Expert Opinion - Flooding and Drainage

Amendment C407 to the Melbourne Planning
Scheme

Victorian Planning Authority

Report Author:	Warwick Bishop
Title:	Expert Opinion Report – Flooding and Drainage
Location:	Arden Macaulay Precinct
Report Prepared For:	Victorian Planning Authority
Instructed By:	Aaron Shrimpton (Harwood Andrews)
Panel Hearing:	Amendment C407 to the Melbourne Planning Scheme
Date of Report	24 January 2022
Document Name	22010153_R01_v01c.docx

Figure 8-1 Time of Inundation at Langford Street Low Point (source: Engeny, 2021)

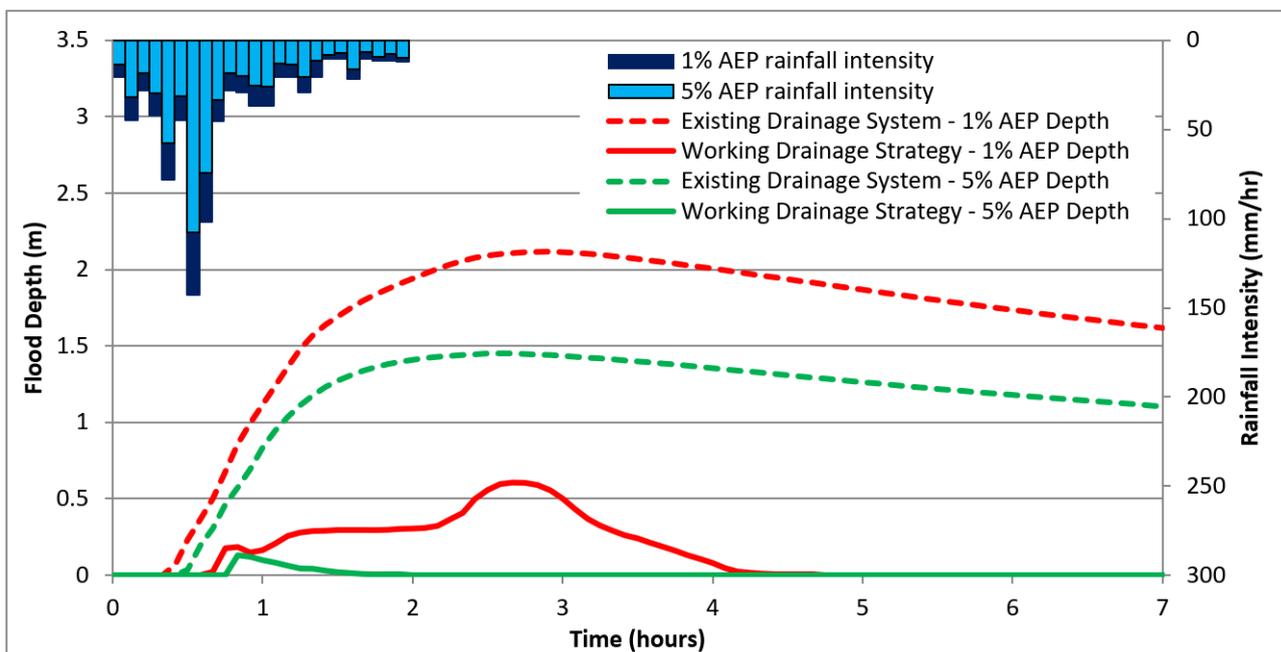
- Flood depths greater than 0.5 m for the 1% AEP design flood (when pumps operate effectively) along Langford Street and lasting for just under 1 hr (see Figure 8-1).
 - It is likely that unsafe conditions, not meeting Melbourne Water's requirement re: safety access, occur elsewhere within the Precinct.
- 5% AEP flood extent impacting private properties (see Figure 8-3).

Based on the above, it is likely that additional measures will be required to address site-specific flooding issues. This may require additional pipe upgrades (to further alleviate flooding on private properties), raising of roads and paths for access and/or the preparation of Flood Emergency Response Plans as part of a total flood warning system. All of these measures can be considered as part of the planning stage for individual development applications. Alternatively, it may be more appropriate for precinct scale flood response measures to be co-ordinated by Council and Melbourne Water. This would address flood risk at the community scale and not rely on a fragmented approach to flood management with individual properties having separate measures in place. I anticipate the following would occur:

Figure 8-2 1% AEP (with Climate Change) Flood Extent and Depths – with Drainage Strategy in Place

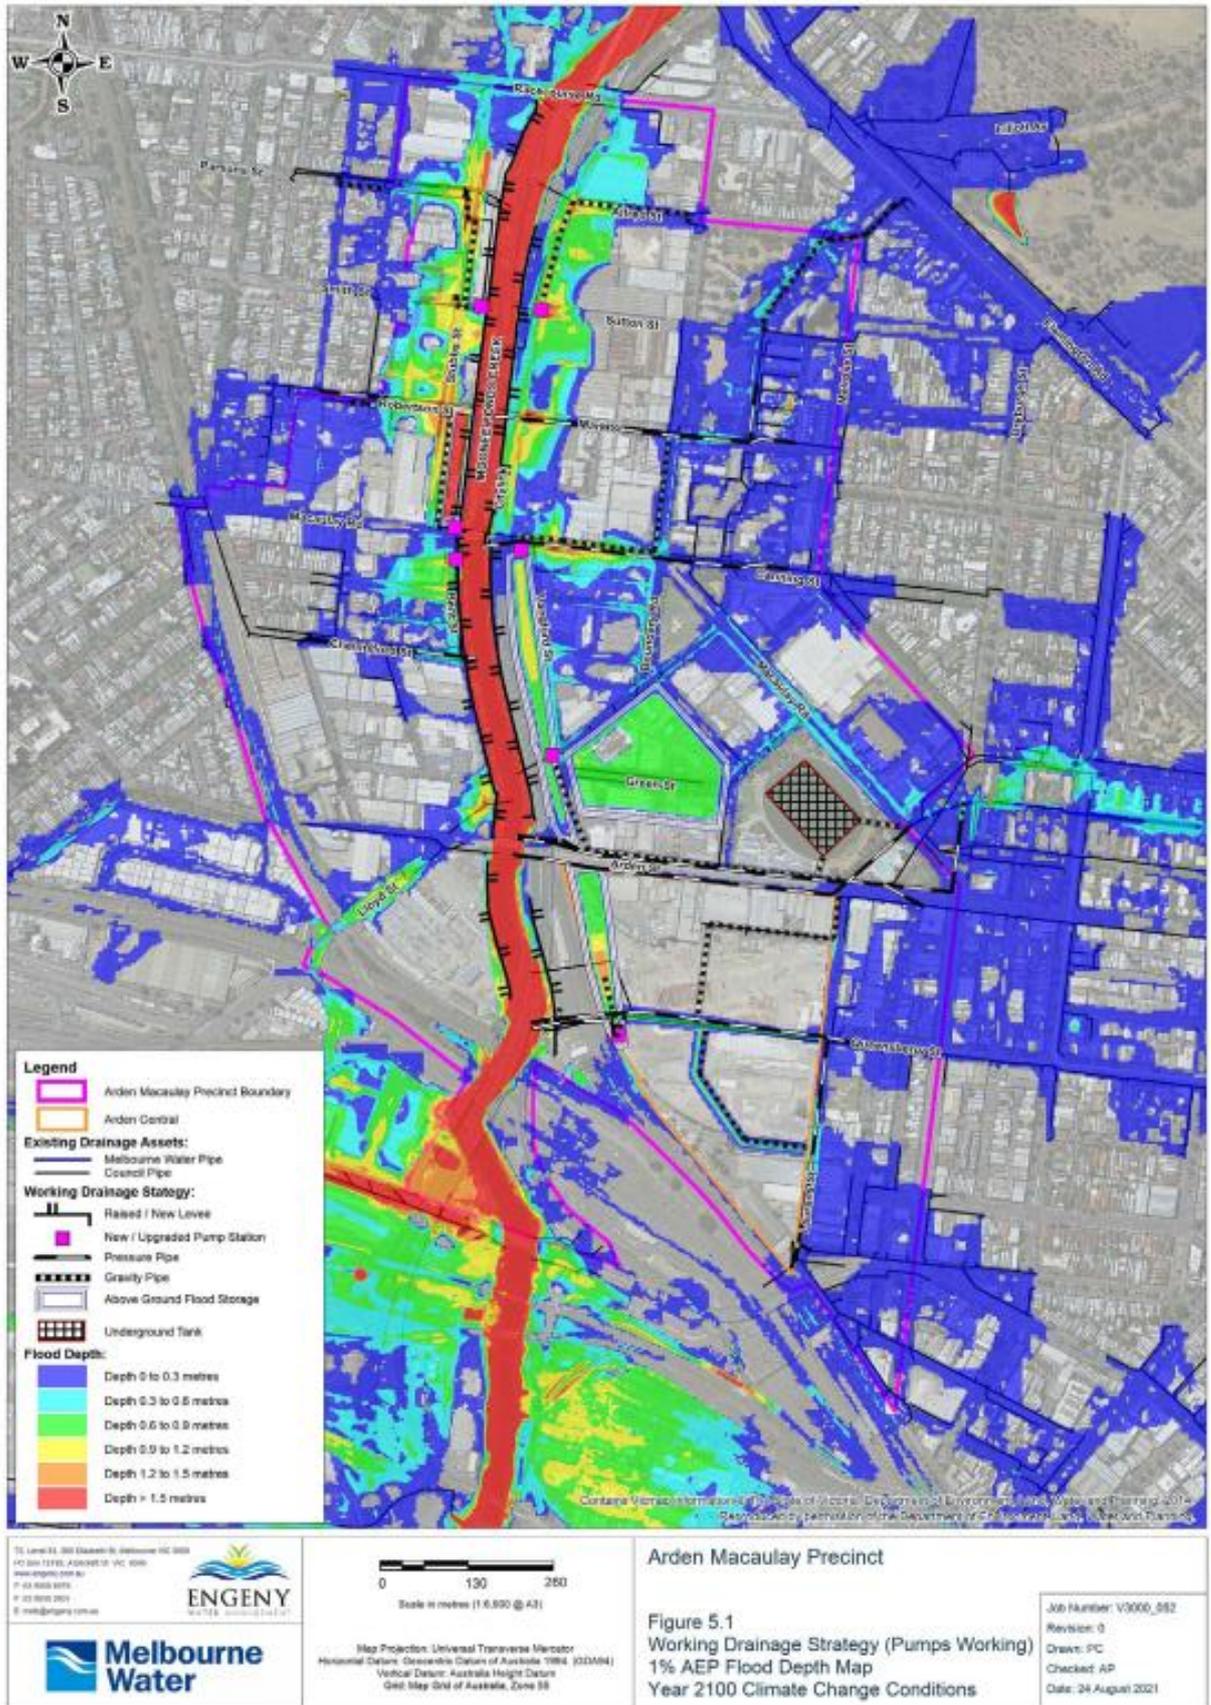
The proposed Working Drainage Strategy will not eliminate flooding within the Arden precinct. Flood impacts will be significantly reduced compared to existing conditions and to more manageable levels, as shown in Figure 8-2. Additional measures will be required to respond to residual flood risk contemplated by the Arden drainage strategy, post-works, as follows:

Figure 8-4 Afflux Map, 1% AEP Design Storm (source: Engeny, 2021)

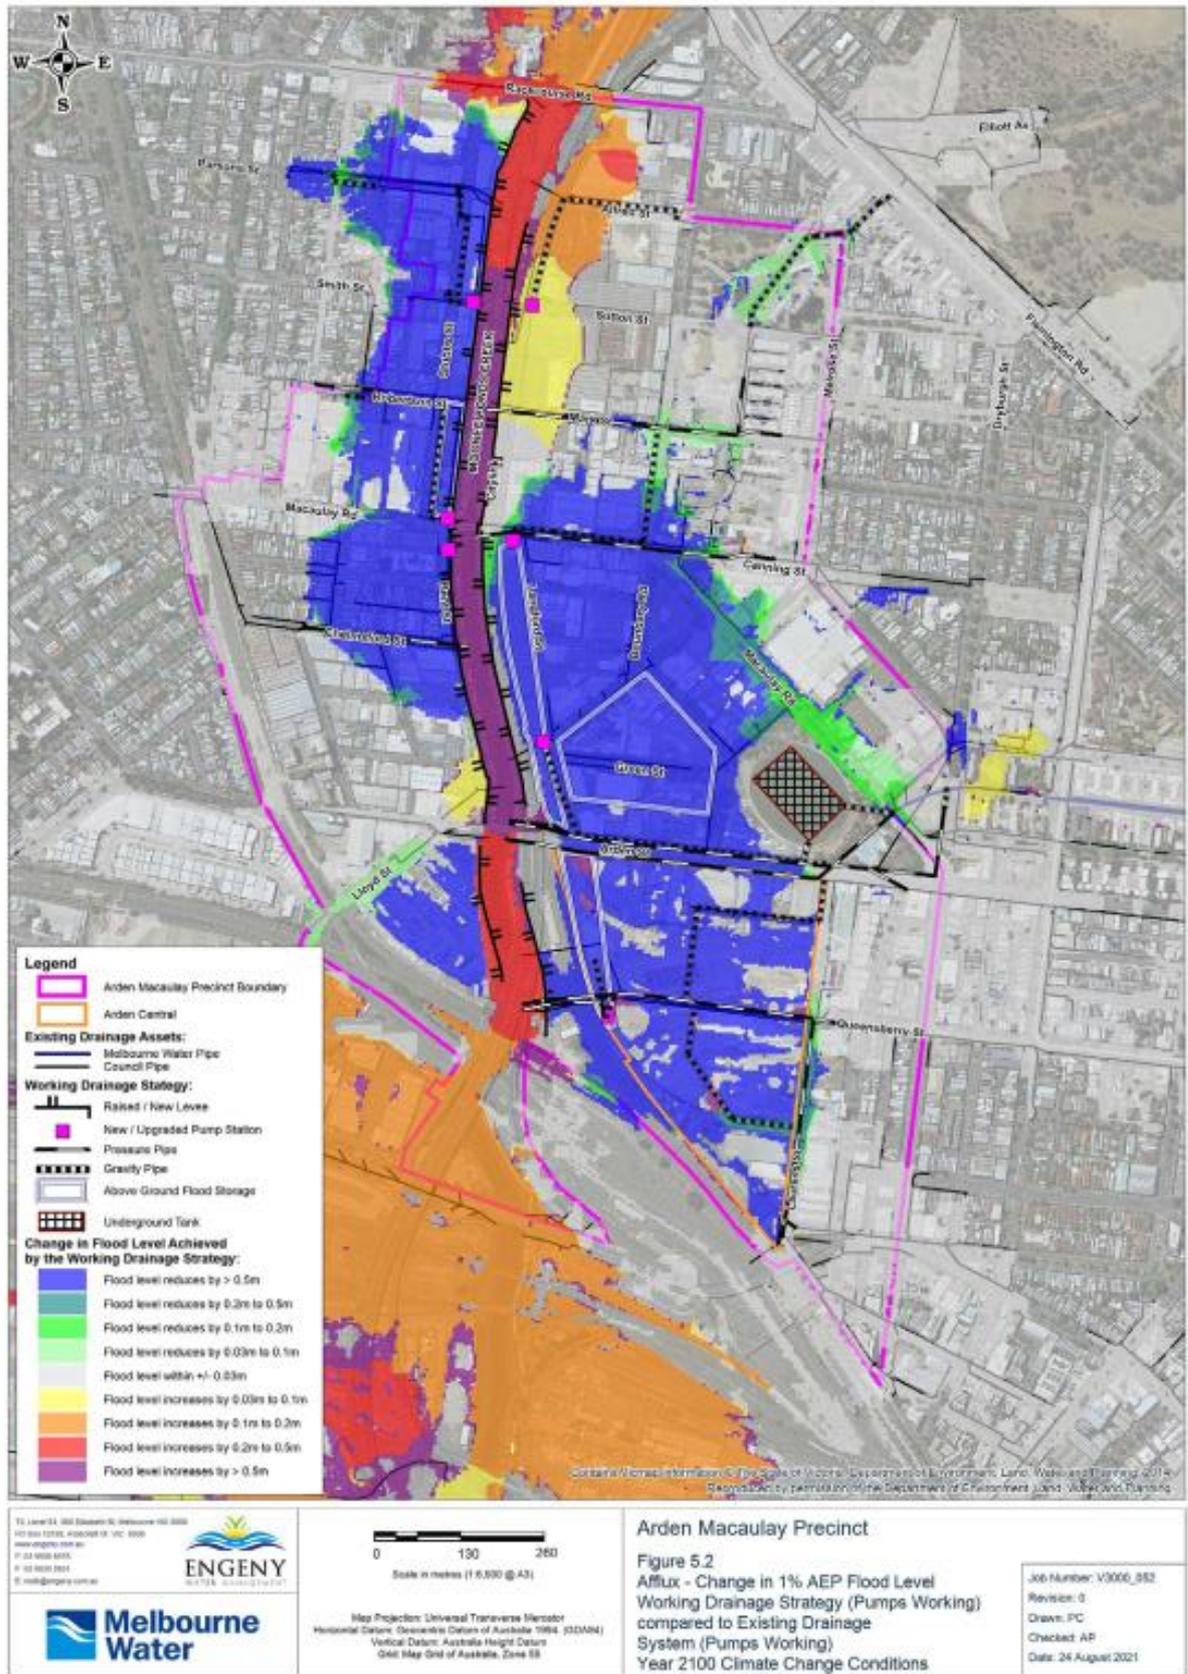
- It is important to note that the 1% AEP flood levels increase for areas outside of the Arden Precinct. These are shown by the warm tone colours in Figure 8-4.

- Some of the predicted increases are up to 500 mm, which would be greater than the freeboard allowed for in overland flow areas (typically 300 mm) and the majority of the freeboard allowed for riverine flooding areas (typically 600 mm).

The Arden Macaulay Precinct Flood Management Strategy modelling (see Figure 8-4) predicts there to be significant peak flood level increases (afflux) upstream and downstream of the Arden Macaulay Precinct, including areas not currently covered by an SBO/LSIO. This shows broad areas of 100 to 200 mm predicted increase downstream, with up to 500 mm and greater in isolated locations. There are also predicted to be increases within the strategy area itself, however these are generally considered acceptable, as residual flood risks can be managed through the redevelopment process. It is a standard requirement of Melbourne Water and Council – in accordance with DELWP’s *Guidelines for Development in Flood Affected Areas* (2019) – that there is no increase in peak design flood levels on adjoining land over a range of storm magnitudes and in particular for the 1% AEP design storm.

Figure 8-4 provides an afflux map which shows the potential impact of the flood mitigation works within the Arden and Macaulay Precincts for the 1% AEP design storm, 2100 climate conditions. It is evident that there is generally a significant reduction in flood levels across the Arden North and Arden Central precincts, as shown with the blue and green colours across the precincts. As noted above, there are also detrimental impacts upstream and downstream of the Arden and Macaulay Precincts, as shown with the yellow, orange, red and purple colours. The afflux shown in Figure 8-4 exceeds acceptable limits for development.

It is important that this external impact is addressed prior to the implementation of the flood management strategy. Investigations to date have clearly focussed on the development of a working strategy to mitigate flooding within the Arden and Macaulay precincts. Through the detailed design and implementation process for the flood management strategy, Melbourne Water will need to further investigate the external impacts and ensure they are appropriately addressed.

- Identifying the full extent of potential flood impact (afflux) upstream and downstream.
- Determine different levels of impact and which areas and landowners are affected.
- Explore mitigation options to address impacts. This could include:
 - Agreements (dispensation) of affected landowners (public or private).
 - Optimisations of the working drainage strategy to reduce off-site impacts.
 - Local mitigation measures for areas outside the Arden and Macaulay precincts to address flood impacts at the local or site scale. This could include options such as bunding or flood proofing.

- Further modelling to refine and optimise (where possible) the Arden Macaulay Precinct Drainage Strategy to minimise external flood impacts. I consider that this can occur without any changes to the Arden Structure Plan as it would only involve modifications the current design, within existing footprints.
- Explore what agreements and/or dispensations may be sought from affected landowners where unacceptable flood impacts are predicted.
